# Access Compliance Report

### (Curb Ramps)

Intersection ID: 15555	Main Street: EASTOVER RIDGE DR	Cross Street: RANDOLPH RD	Location: SW
ADA ID: 64B22DC9A3EF	Ramp Type: PerpDiag	Initial Pass/Fail: Fail	Overall Compliance: No
Severity Score: 12.5			
Codes/Mitigation Info/Possible Solution		Field Measurements/Component Compliance

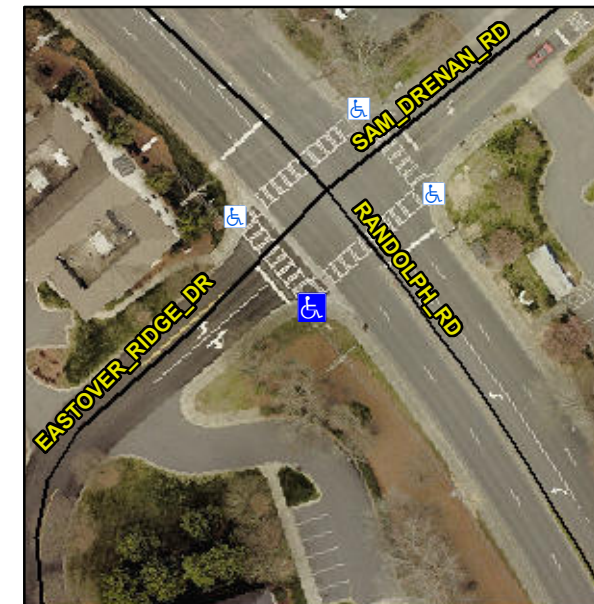
**Not Found, R304.2.2**

Compliance	Description	Data	Compliance	Description	Data
N/A	Ramp Length (in)	72.0	No	Ramp Slope (%)	10.1
Yes	Ramp Width (in)	48.0	Yes	Ramp XSlope (%)	1.9
N/A	Flare Type LT	N/A	N/A	Flare Type RT	N/A
N/A	Flare Slope LT (%)	N/A	N/A	Flare Slope RT (%)	N/A
N/A	Flare Traversable LT?	N/A	N/A	Flare Traversable RT?	N/A
N/A	Landing Length (in)	N/A	N/A	DWS Provided?	N/A
N/A	Landing Width (in)	N/A	N/A	DWS Contrast?	N/A
N/A	Landing Slope (%)	N/A	N/A	DWS Length (in)	N/A
N/A	Landing X Slope (%)	N/A	N/A	DWS Full Width?	N/A
N/A	Landing Curb? (Y/N)	N/A	N/A	DWS Offset (in)	N/A
N/A	Shared Landing?	N/A			
N/A	Gutter Ponding?	N/A	N/A	Gutter Slope (%)	N/A
N/A	Gutter Lip Ht (in)	N/A	N/A	Gutter X Slope (%)	N/A
N/A	Painted X Walk1?	Yes	N/A	Painted X Walk2?	Yes
	X Walk 1 Direction	To NE		X Walk 2 Direction	To NW
N/A	X Walk 1 Width (in)	81.0	N/A	X Walk 2 Width (in)	83.0
	X Walk 1 Slope (%)	6.6		X Walk 2 Slope (%)	1.2
	X Walk 1 X Slope (%)	0.9		X Walk 2 X Slope (%)	0.2

**Remove & Replace Curb Ramp With Two New Directional Ramps or Equivalent. Restripe Crosswalk.**
